April 21, 2022

An Addendum to the Previously Certified Environmental Impact Report for the Soitec Solar Development Program

FOR PURPOSES OF CONSIDERATION OF RUGGED SOLAR PROJECT

**PDS2017-MUP-12-007W1, PDS2017-MUP-12-007TE,
PDS2017-ER-12-21-0005A**

FIGURE 1-3

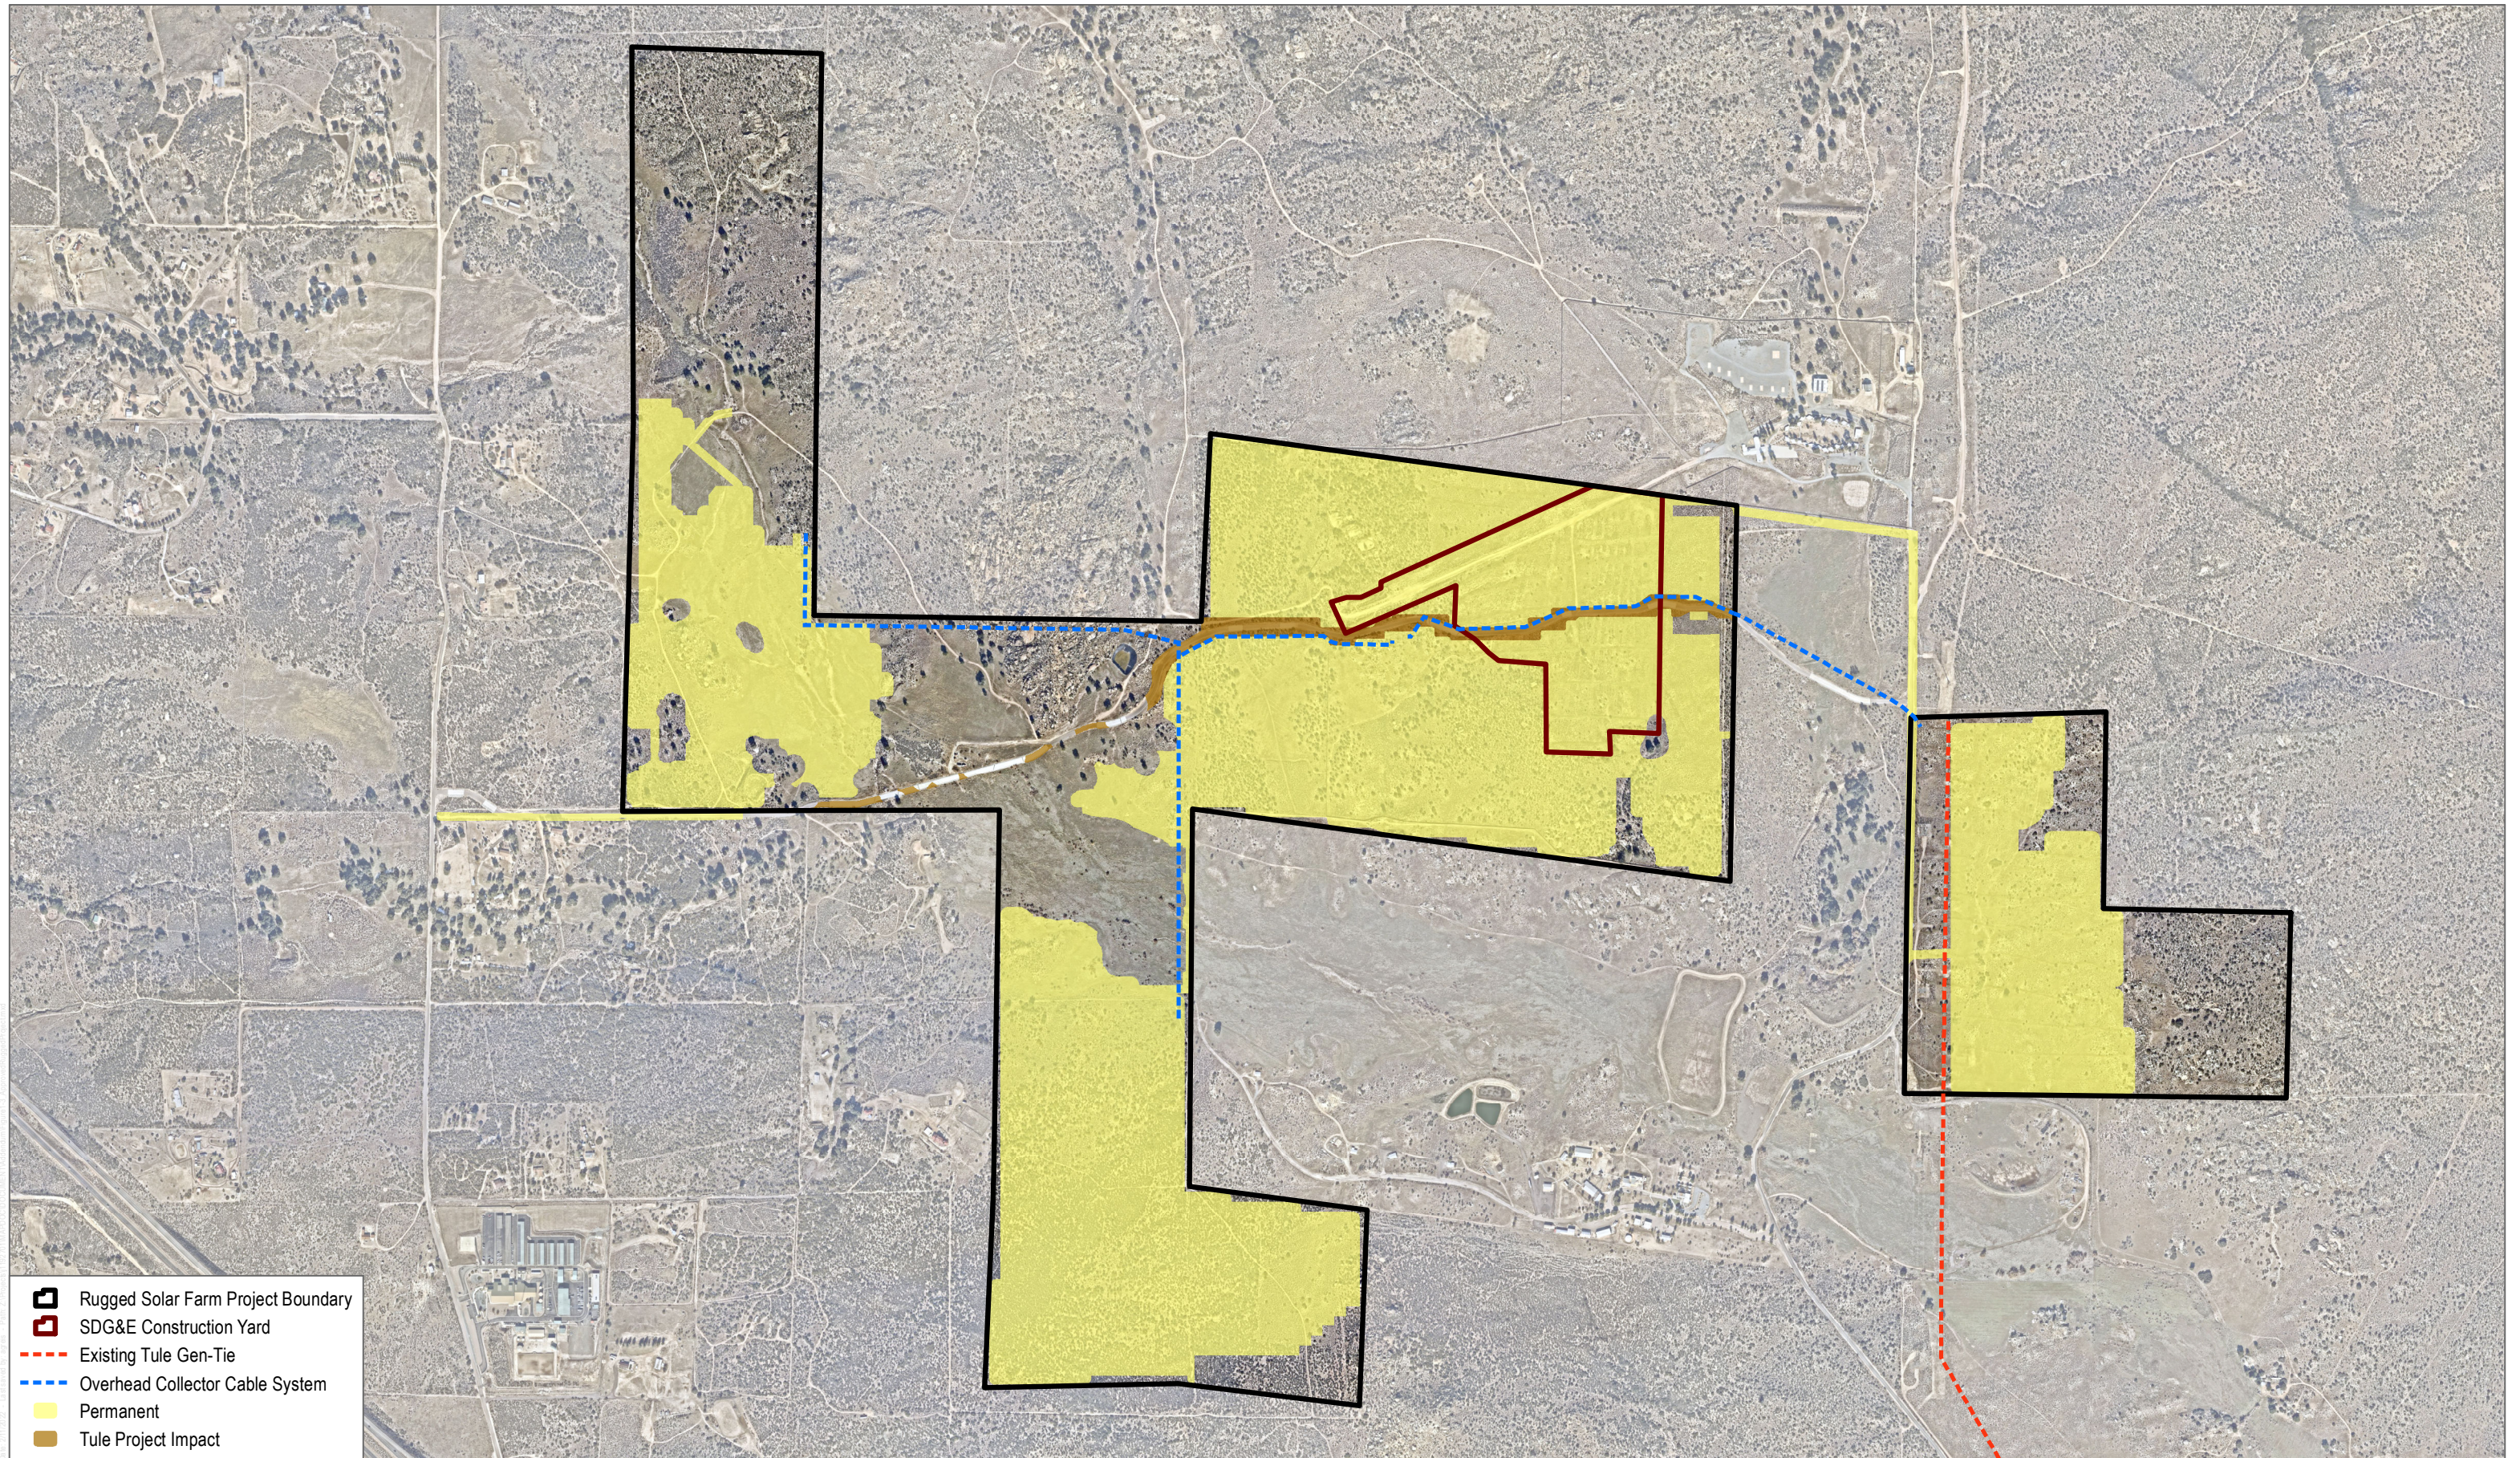
and maximum height of 35 feet, including a 450-square-foot control house. A generation tie (gen-tie) line from the site is approved to connect to a co-located gen-tie line with the Tule Wind Energy Project. The co-located gen-tie line is approved to deliver power from the Approved Rugged Project's substation to the 69-kilovolt bus at San Diego Gas & Electric's Rebuilt Boulevard Substation (see Figure 1-3, Approved Rugged Project).

FIGURE 1-4

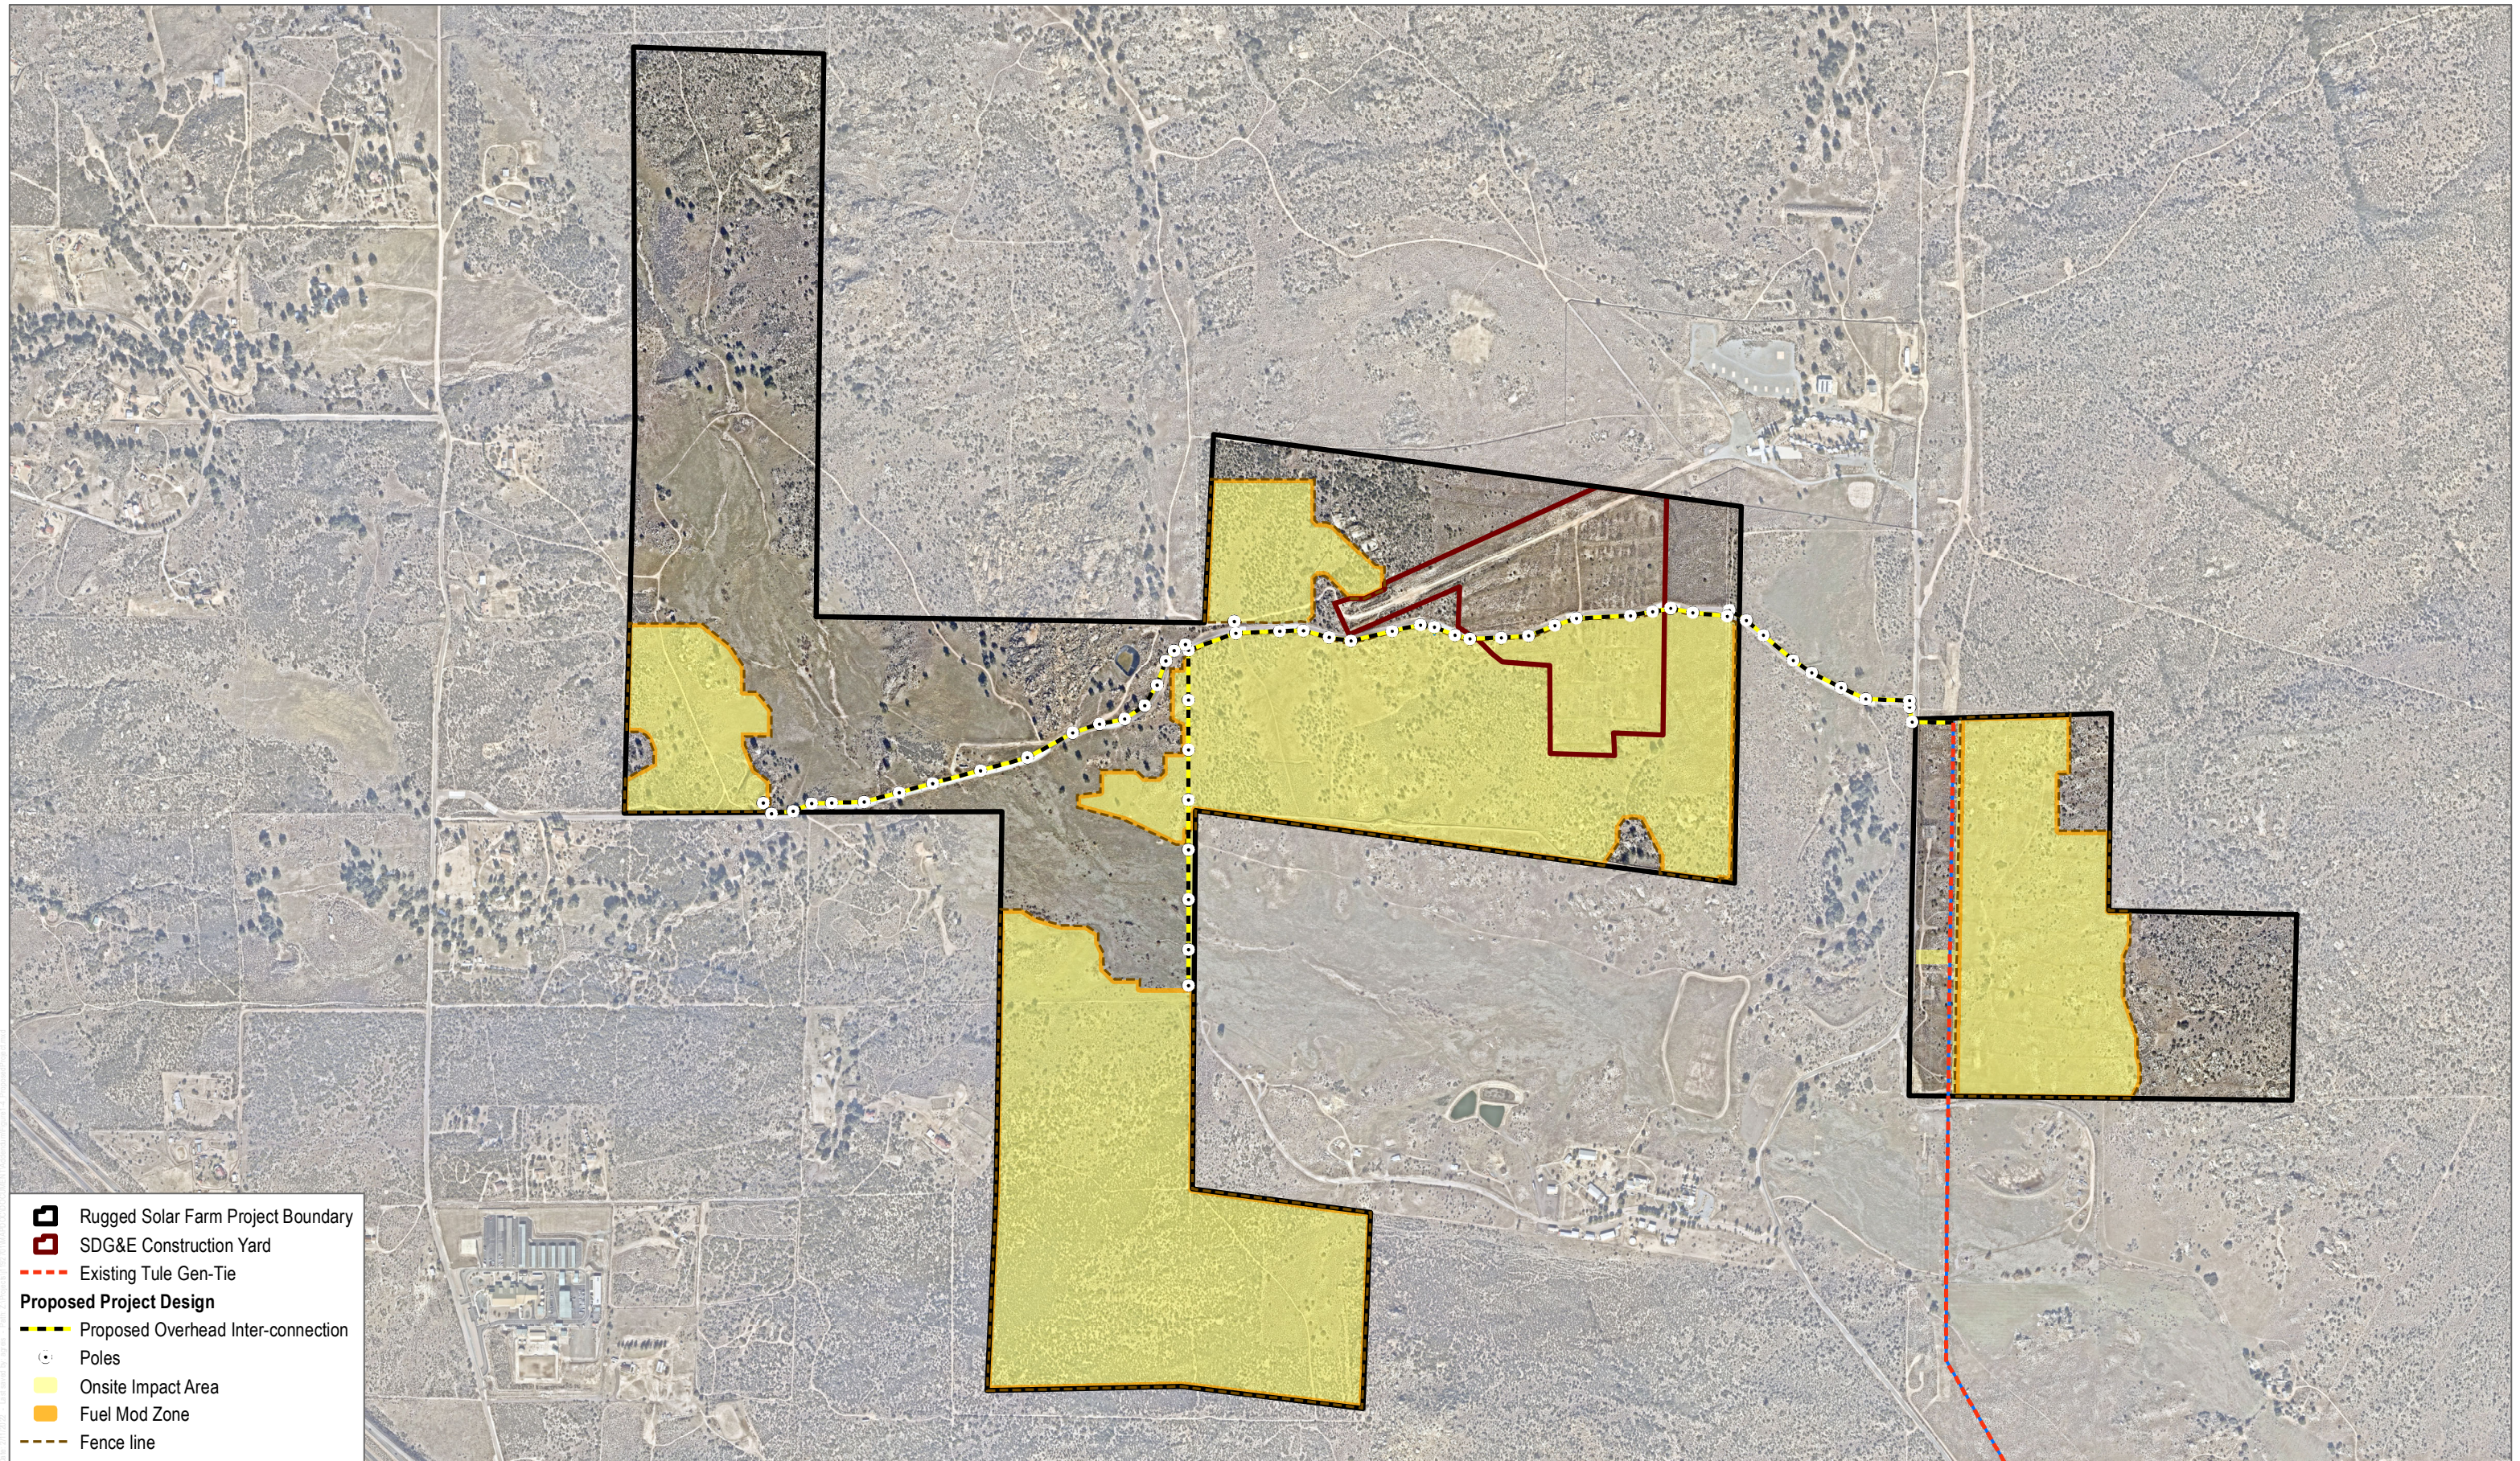
The Proposed Project would include a larger on-site collector substation that would increase the size of the substation from 6,000 square feet as analyzed under the Approved Rugged Project to 26,000 square feet (see Figure 1-4, Proposed Rugged Project). Components for the Proposed Project are listed in Table 2.
